DUANE ARNOLD ENERGY CENTER

AMENDMENT TO FACILITY OPERATING LICENSE

Amendment No. 10
License No. DPR-49

ATTACHMENT TO LICENSE AMENDMENT NO. 10
CHANGE NO. 11 TO THE TECHNICAL SPECIFICATIONS
FACILITY OPERATING LICENSE NO. DPR-49
DOCKET NO. 50-331

DAEC Emergency Service
Water Flow Requirement
Figure 4.8.C-1

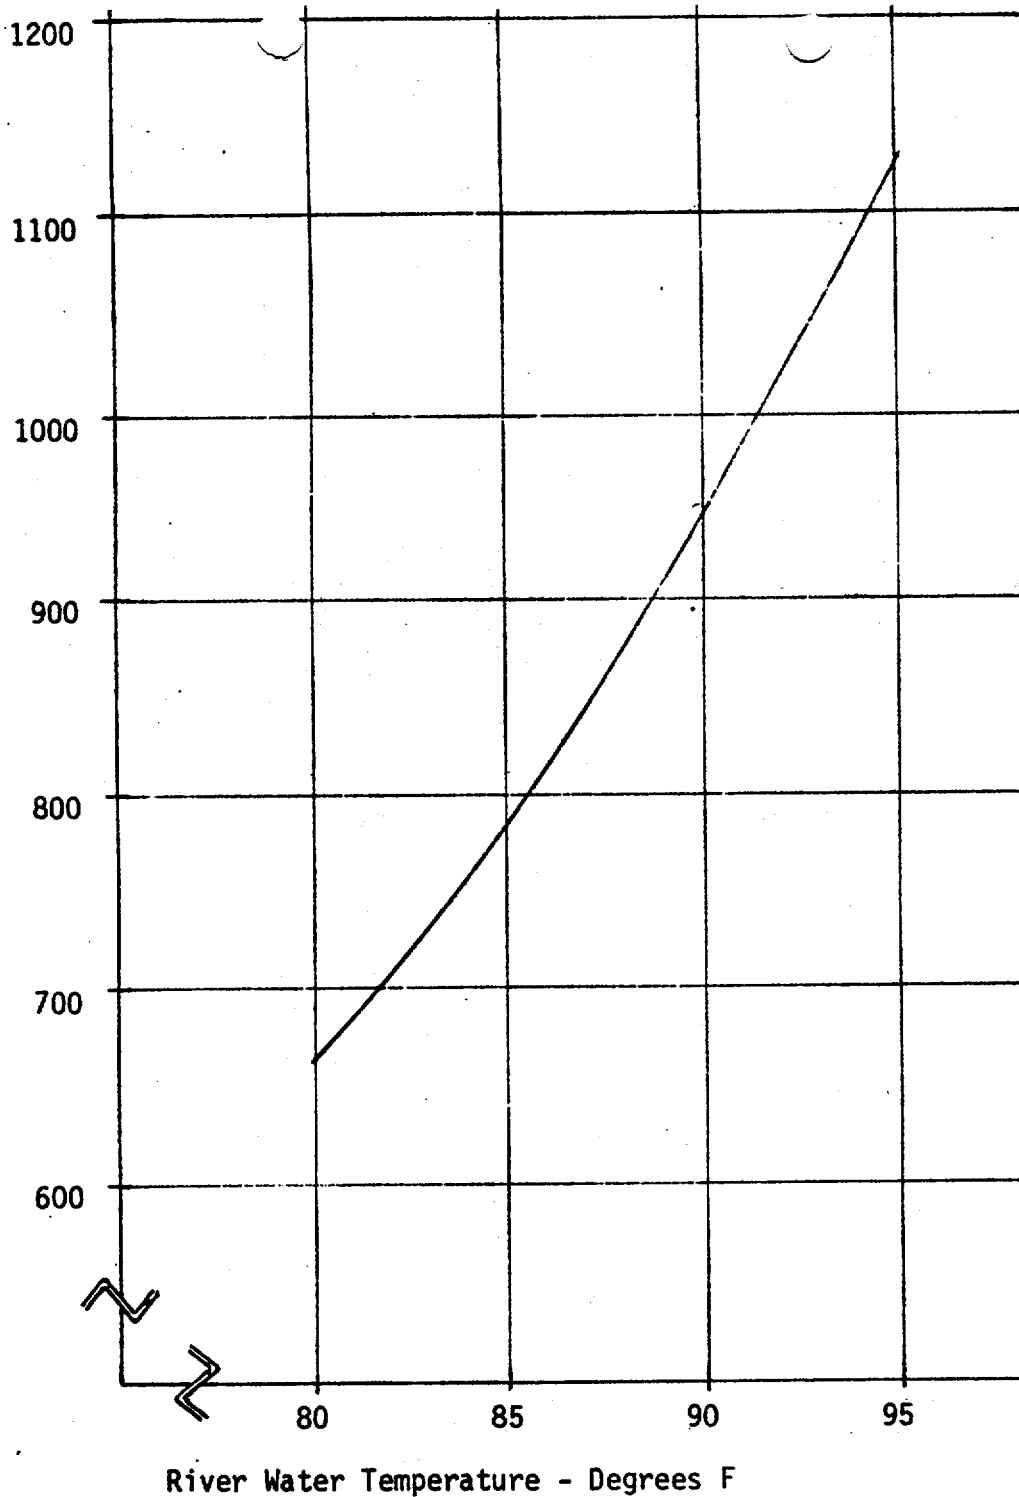
Insert Figure 4.8.c-1, page 3.8-6a.

LIMITING CONDITIONS FOR OPERATION	SURVEILLANCE REQUIREMENTS
<p>C. <u>Emergency Service Water System</u></p> <p>1. Except as specified in 3.8.C.2 below, both emergency service water system loops shall be operable whenever irradiated fuel is in the reactor vessel and reactor coolant temperature is greater than 212°F.</p> <p>2. From and after the date that one of the emergency service water system pumps or loops is made or found to be inoperable for any reason, reactor operation must be limited to seven days unless operability of that system is restored within this period. During such seven days all active components of the other Emergency Service Water System shall be operable, provided the requirements of 3.5.G are met.</p> <p>3. If the requirements of 3.5.C cannot be met, an orderly shutdown shall be initiated and the reactor shall be in a Cold Shutdown condition within 24 hours.</p>	<p>C. <u>Emergency Service Water System</u></p> <p>1. Emergency Service Water Subsystem Testing</p> <p>a. Simulated automatic actuation test. each refueling outage</p> <p>b. Pump and motor operated valve operability once/3 months</p> <p>c. Flow Rate Test</p> <p>Each emergency service water pump shall deliver at least that flow determined from Figure 4.8.C-1 for the existing river water temperature. after major pump maintenance and every month except weekly during periods of time the river water temperature exceeds 80°F.</p> <p>2. When one emergency service water system pump or loop becomes inoperable, the operable pump and loop and diesel-generator required for operation of such components shall be demonstrated to be operable immediately and daily thereafter.</p>

FIGURE 1

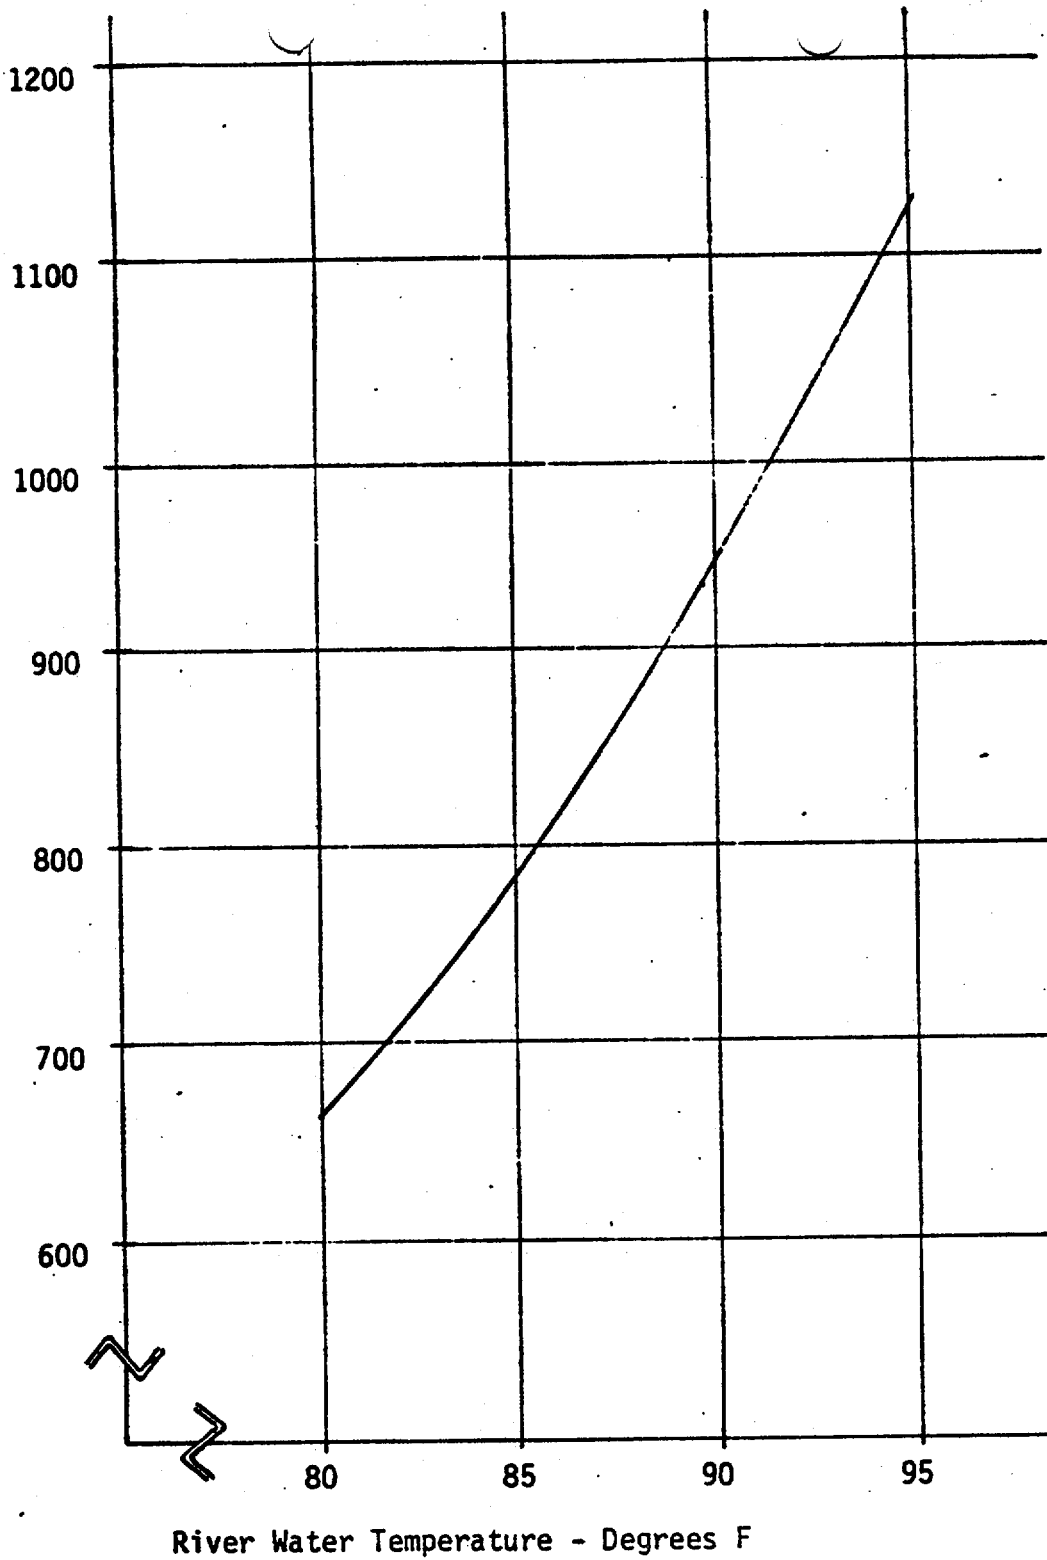
IELP has calculated the ESW system flow rates required to provide adequate component cooling at river water temperatures of 80°F, 85°F, 90°F, and 95°F as shown on table 1 and figure 1 attached hereto. The requirement for only 1129 gpm flow at 95°F compared to 1200 gpm in the current Technical Specifications is the result of a reduction of 75 gpm in the diesel generator flow requirement as determined by the manufacturer based on a review of actual cooling requirements. Based on the flow rates shown on table 1 and figure 1, IELP stated that the pump that was recently tested can supply adequate ESW system cooling flow only at a river water temperature of 91°F or less.

IELP's proposed change to the Technical Specifications would establish the required ESW system flow rate by using the system flow rate versus river water temperature shown on table 1 and figure 1. The flow rate of each ESW system will be measured periodically and after specific events, e.g., after major pump maintenance and on a monthly schedule except weekly measurements will be taken when the river water temperature exceeds 80°F. The river water temperature is logged hourly by the plant computer.

The proposed Technical Specification will require that the total flow rate of an ESW system meet or exceed the required flow rate shown on figure 1 for the measured river water temperature. If the total flow rate of an ESW system does not meet this specification, the flow rate must be restored to the specified value within seven days or the reactor must be shut down.

The basis for the specification of the ESW system flow rate is to assure that there will be adequate cooling supplied to the components shown on table 1 (and on Figure 1) in case of a postulated accident. Based on our review and analysis of IELP's proposed ESW system flow rates as a function of river water temperature, we find that adequate cooling will be provided to the emergency equipment if the flow rates of each ESW system equal or exceed the flow rates for the river water temperatures as shown on figure 1 and in table 1. Accordingly, we have determined that specification of an ESW flow rate of 1200 gpm under all circumstances and without regard to river water temperature is not required to meet the limiting conditions of operation of the ESW system for this facility. Further, either the ESW pumps are required to provide adequate flows at the temperatures shown on Figure 4.8.C-1 (Section 4.8.C.1.c of the Technical Specifications) or the facility must be shut down; thus, adequate cooling will be provided in the unlikely event of an accident during reactor operation. We conclude that IELP's proposed Technical Specification is acceptable.
